PRELIMINARY
OVERALL AREA DEVELOPMENT PLAN
FOR
THE HILLS OF WESTCREEK

CITY OF SAN ANTONIO

RE: The Hills of Westcreek Subdivision POADP #481

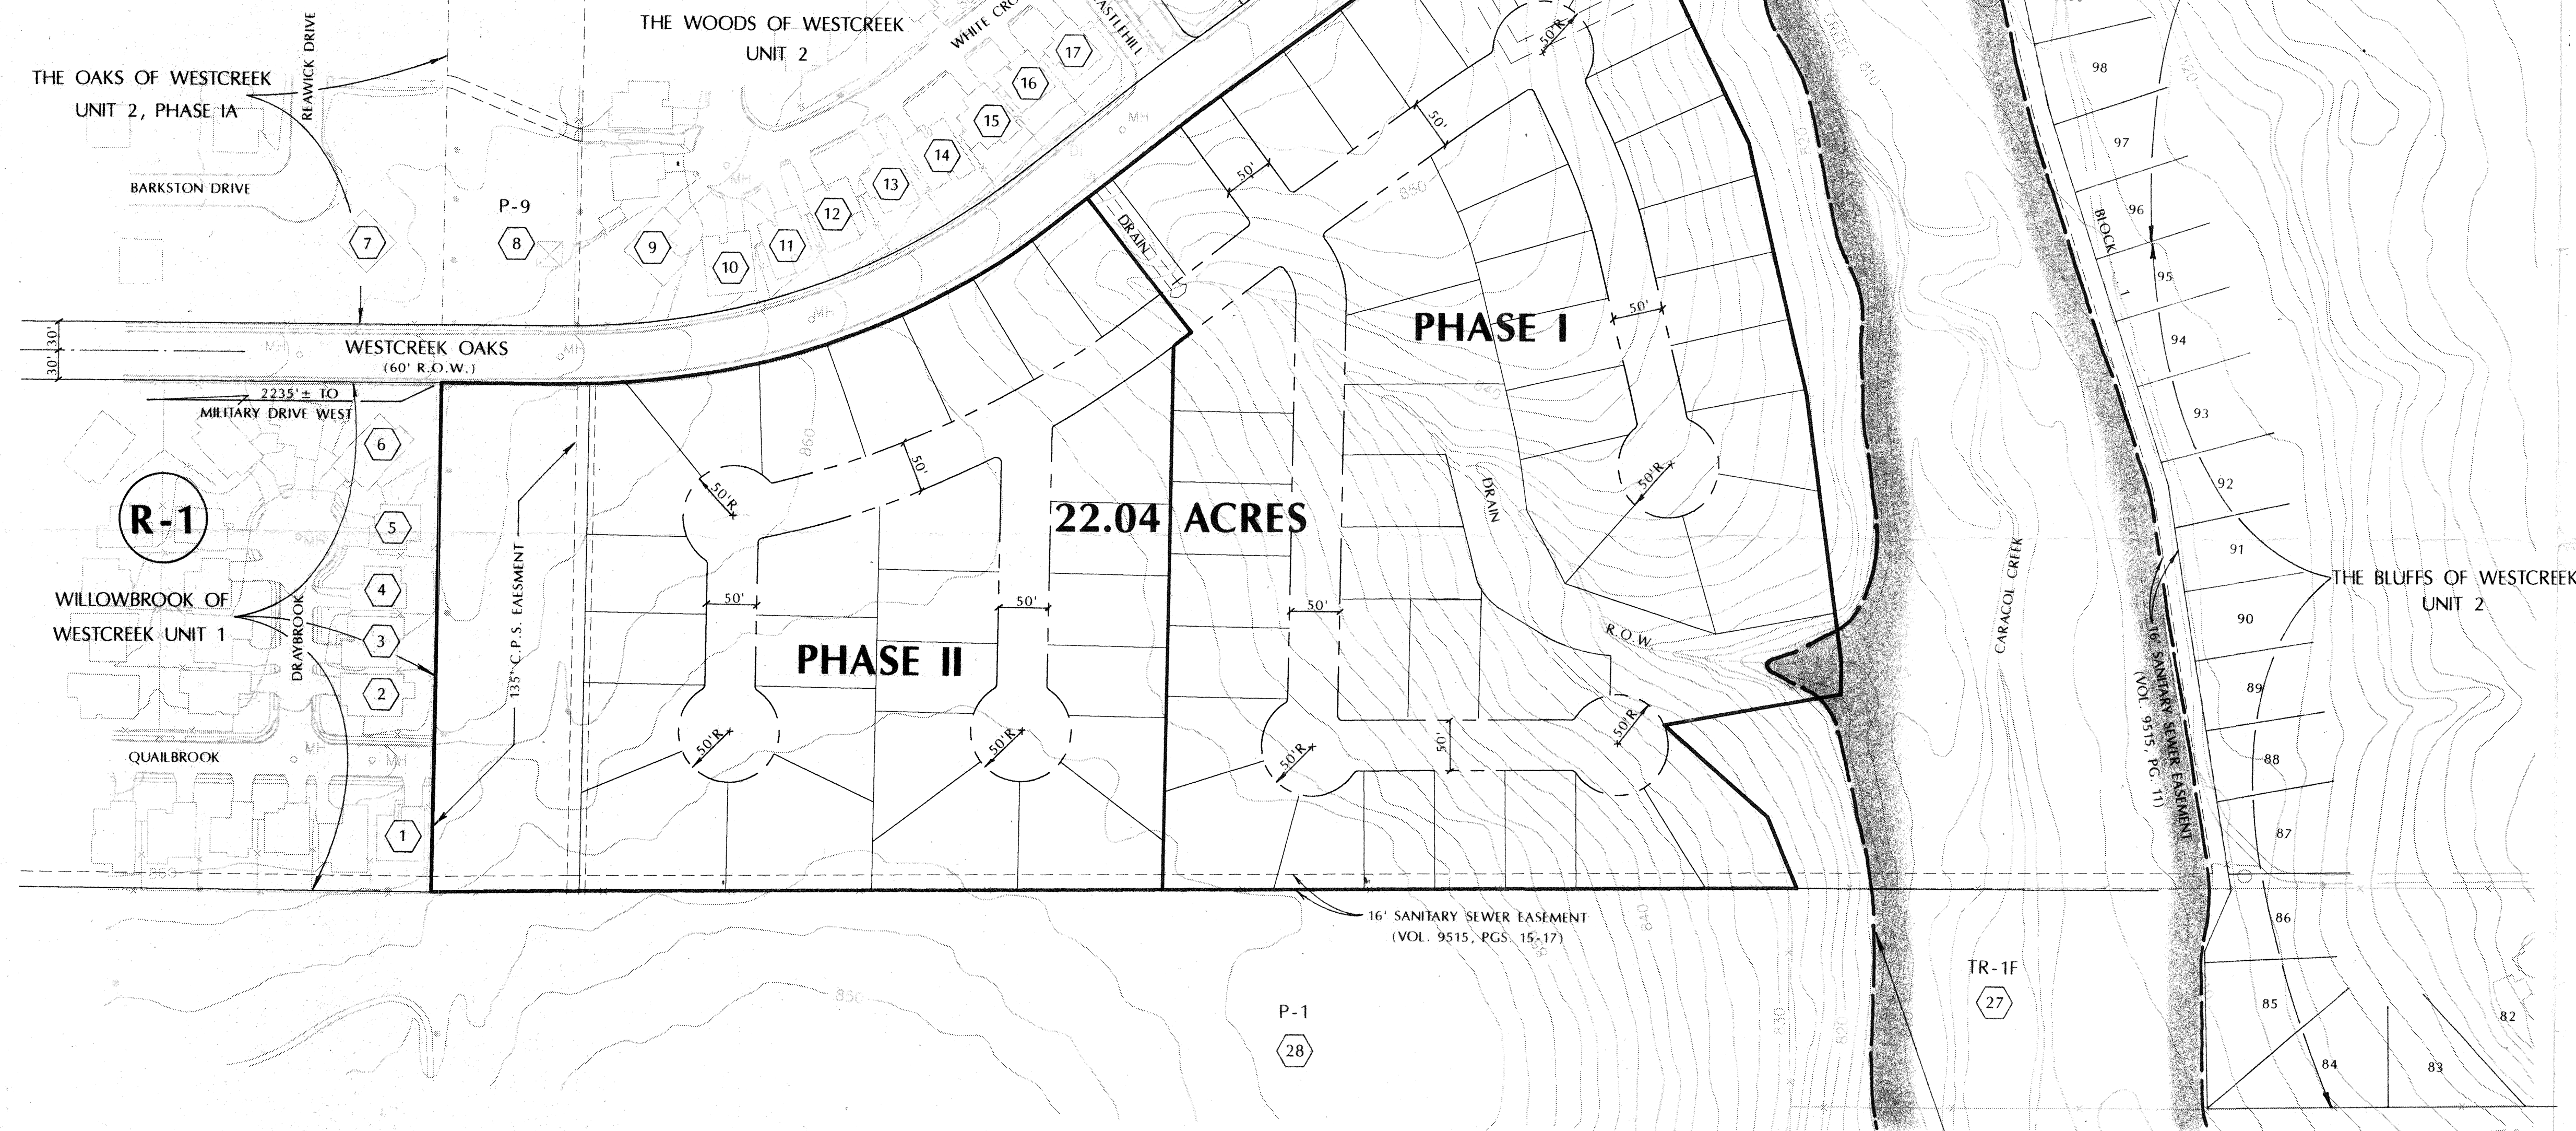
Although your plan was accepted, a non-access easement will be required along the rear of all single-family residential lots adjacent to Westcreek Oaks. Additionally, the entry street needs to be platted, dedicated, and constructed at collector street standards to accommodate traffic flows into and out of the subdivision.
